# UNITED STATES PATENT AND TRADEMARK OFFICE

APPLICATION NO.	FILING DATE	FIRST NAMED INVENTOR	ATTORNEY DOCKET NO.	CONFIRMATION NO.
10/527,524	10/15/2005	Kendall Munday	DAVI254.001APC	3219
20995 7590 01/10/2008 KNOBBE MARTENS OLSON & BEAR LLP 2040 MAIN STREET FOURTEENTH FLOOR IRVINE, CA 92614			EXAMINER BRADFORD, CANDACE L	
			ART UNIT 3634	PAPER NUMBER
			NOTIFICATION DATE 01/10/2008	DELIVERY MODE ELECTRONIC

# Office Action Summary

FIG. 11

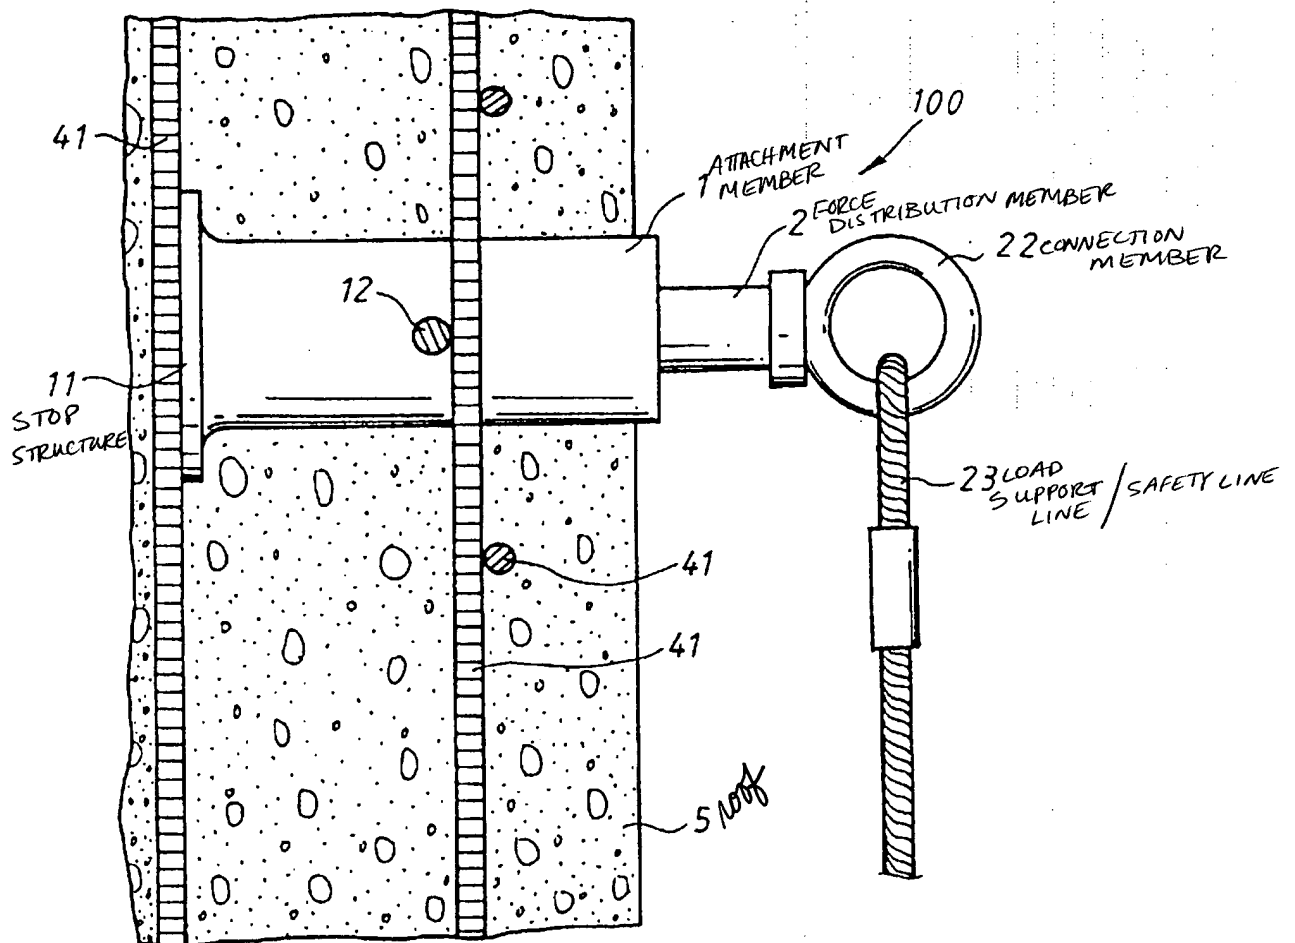
Claim 1-8, 15, 21, and 29 are rejected under 35 U.S.C. 102(b) as being anticipated by Chiou et. al. (5758742). Chiou et. al. discloses an attachment member 1, adapted to attach to an edge region of a roof 5, a force distribution member 2, extending transversely to the attachment member and adapted for location on an upper surface of the roof, a connector 22, mounted to the attachment member of the force distribution member, the connector adapted to receive a load support line 23, wherein the connector is positioned in the vicinity of a junction between the attachment member and the force distribution member as best seen in attached Figure 11, wherein the connector is positioned in a lower half of the force distribution member, wherein the connector is positioned in a lower quarter of the force distribution member, wherein the connector is positioned within fifty centimeters of a junction of the force distribution member and the attachment member, wherein the connector is positioned within twenty five centimeters of the junction, wherein the connector is positioned within ten centimeters of the junction, wherein the connector is portioned at or around the edge of the roof in use, wherein the attachment member includes a stop structure

to engage an edge of the roof, wherein the force distribution member is formed as an elongate cylindrical member preferably tubular, further including a safety line fixed permanently to the connector as best seen in attached Figure 11.

FIG. 1

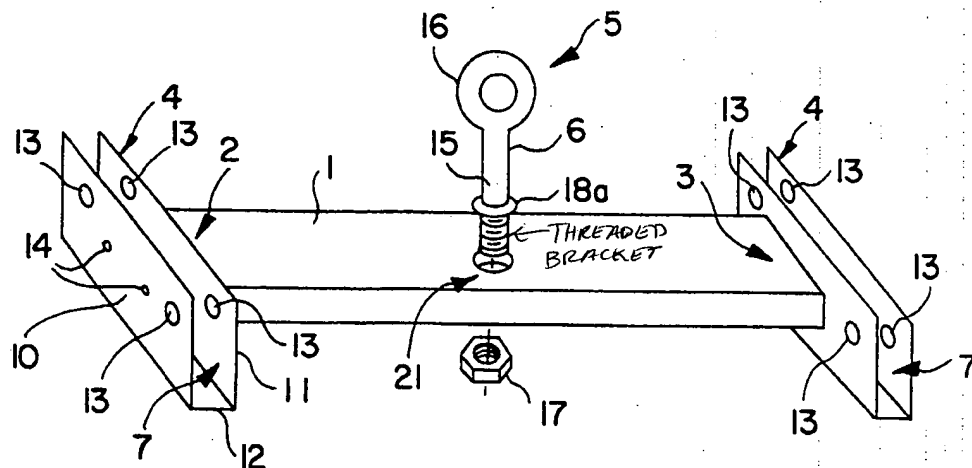
Claims 1, 9, 10, 13-20, 23-26, and 30-33 rejected under 35 U.S.C. 102(b) as being anticipated by Arisman et. al. (5346036). Arisman et. al. discloses an attachment member 4, adapted to attach to an edge region of the roof 8, a force distribution member 1a, extending transversely to the attachment member and adapted for location on an upper surface of the roof, a connector 5, mounted to the attachment member of the force distribution member, the connector adapted to receive a load support line, wherein the connector is positioned in the vicinity of a junction between the attachment member and the force distribution member, wherein the attachment member is formed as an elongate member having a gap formed by a first side structure and a second side structure spaced from the first side structure, the gap adapted to locate around an edge of the roof, as best seen in the attached Figure 2, wherein the first side structure is contoured to conform to a profile of an underside of the roof edge as best seen in Figure 8, wherein the first side structure and second side structure form clamping means for clamping at least a part of the roof edge in the gap, wherein the clamping means is adjustable to vary the gap, wherein the attachment member includes a stop structure to engage an edge of the roof, as best seen in the attached Figure 2, wherein the stop structure is a wall, wherein the second side structure is formed as two shaft members each with a longitudinal axis oriented substantially perpendicular to the first side structure, wherein the two shaft member are

positioned each towards a respective outer end of the elongate members, wherein the shaft members are threadably engaged with support brackets thereby providing adjustment means for adjusting the gap, wherein the force distribution member is substantially perpendicular to the attachment member, wherein the force distribution member is formed as a substantially planar member, wherein the force distribution member includes a foot 4, engaging the roof surface, an attachment foot formed as an elongate L shaped bar, two spaced locking arrangement disposed transversely to one surface of the L shaped bar and positioned to each co-operate with a respective end region of the attachment foot, a cylindrical arm connected approximately centrally to the foot and extending perpendicular thereto, an attachment aperture formed in or mounted on the foot or the arm, wherein the components are configured to compressively engage a roof edge region between one surface of the L shape bar and the locking arrangement, with the arm positionable on the roof and that attachment aperture, in use positioned in the vicinity of the roof edge, wherein the spaced locking arrangements are each a threaded shaft mounted in a threaded bracket and rotatable into and out of contact with the roof to thereby fix the anchor in position, placing an attachment member in contact with an edge of the roof, positioning an arm directed upward on the roof, the arm extending transversely from the attachment member, fixing a safety ling to the roof at or around the level of the roof edge, as best seen in attached Figures 1, 2, and 6.
